**Subject: MHI's Responses to US-APWR DCD RAI No. 148-1700 Revision 1**

Response to Request for Additional Information  
No. 148-1700 Revision 1

**US-APWR Design Certification**

**RAI NO.:** NO. 148-1700 REVISION 1

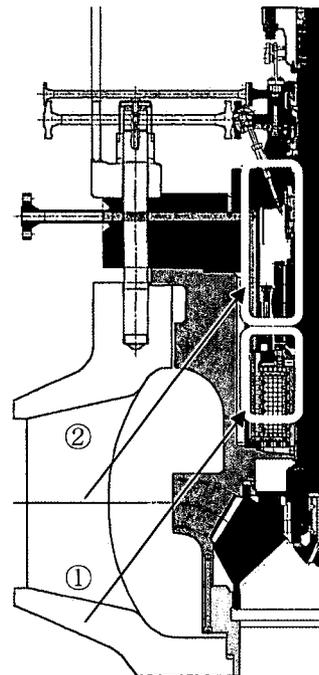
The modeling of Reactor Coolant Pump (RCP) seal LOCAs in the US-APWR PRA are discussed in Appendix 6A.14.2 of Revision 1 of the PRA report. It is stated: "New type O-ring which is improved for resistance to heat and pressure will be used in the USAPWR. But the RCP seal LOCA model for the US-APWR conservatively uses a mode[] for the old type O-ring." However, the old O-ring model was modified by assuming that the maximum leak rate of 480 gpm per RCP will occur if cooling of the seals is lost for more than one hour. Although the assumed leak rate is very conservative (even according to the old O-ring model), the assumption that the RCP seal adopted by the US-APWR can keep its integrity for at least one hour without water cooling is not consistent with either the new or the old O-ring model. According to these models, there is a small probability (about 5E-3) that a leak rate of 480 gpm will develop within 10 to 30 minutes following loss of seal cooling. Please provide a more detailed discussion and the reason for using this "modified" old O-ring model in the US-APWR PRA as well as the basis for the assumption that the adopted RCP seal can keep its integrity for at least one hour without water cooling.

The basis for assuming that the RCP seal can keep its integrity for at least one hour without water cooling is provided in the attachment to this response. As shown in the attachment, the RCP seal can keep its integrity for at least one hour without cooling. It is expected that the leak rate will develop with time after RCP seal starts to degrade. However, since the leak rate after RCP seal has degraded is uncertain at this time, the PRA conservatively applies the maximum leak rate of the old O-ring model. For this reason the US-APWR O-ring model assumes no leak during the first hour after loss of cooling, and a leak rate of 480 gpm per RCP beyond the first hour.

In the actual RCP, the high-temperature RCS water is fed into area ① shown in the right figure. The water is then mixed and fed into the upper area, and finally, the shaft seal inlet at the top of area ② will be heated.

Normally, after most of area ① is filled with the high-temperature water, the high-temperature water will be fed into area ②. For this evaluation, however, we set the condition on the safety side that the water should be completely mixed in areas ① and ② at the same time, and the seal temperature should rise comparatively quickly.

We set the seal injection water capacity (areas ①+ ② in the right figure) to 518lbm(235kg,235L), and assumed that the high-temperature RCS water fed into the seal injection water area would be immediately mixed with the seal injection water of the above capacity to uniform the temperature.
